Lal Lal Wind Farm

Planning Permit PL-SP/05/0461

Application to amend permit

Shane Cramer Group Officer Ballan Group of Fire Brigades

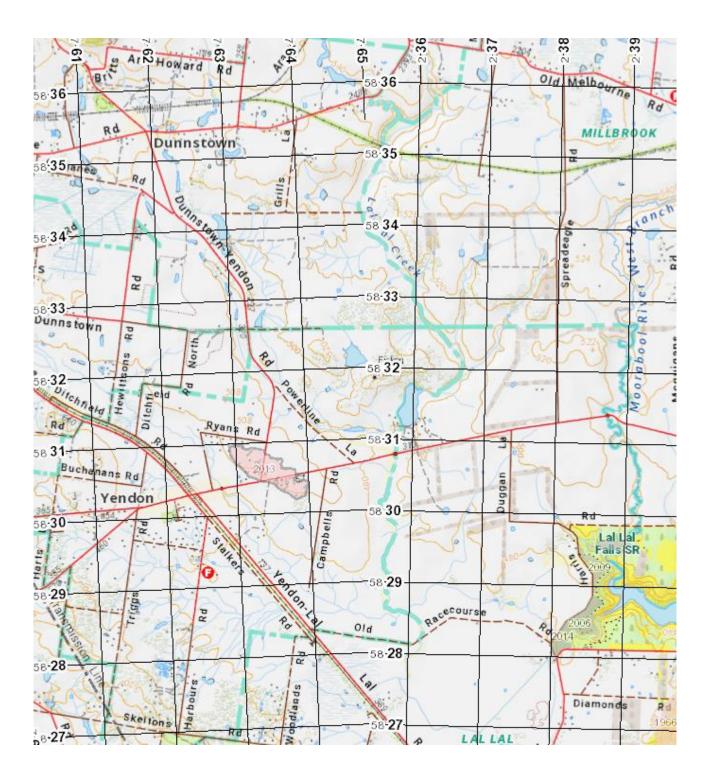
I understand that some of the separations for the Lal Lal wind-farm are as little as 280 metres, leaving only a 140 metre separation between the 70 metre blade tips, which seems to me to be a drastic reduction in the 210 meter blade tip separation of 45 metre blades, on towers 300 metres apart.
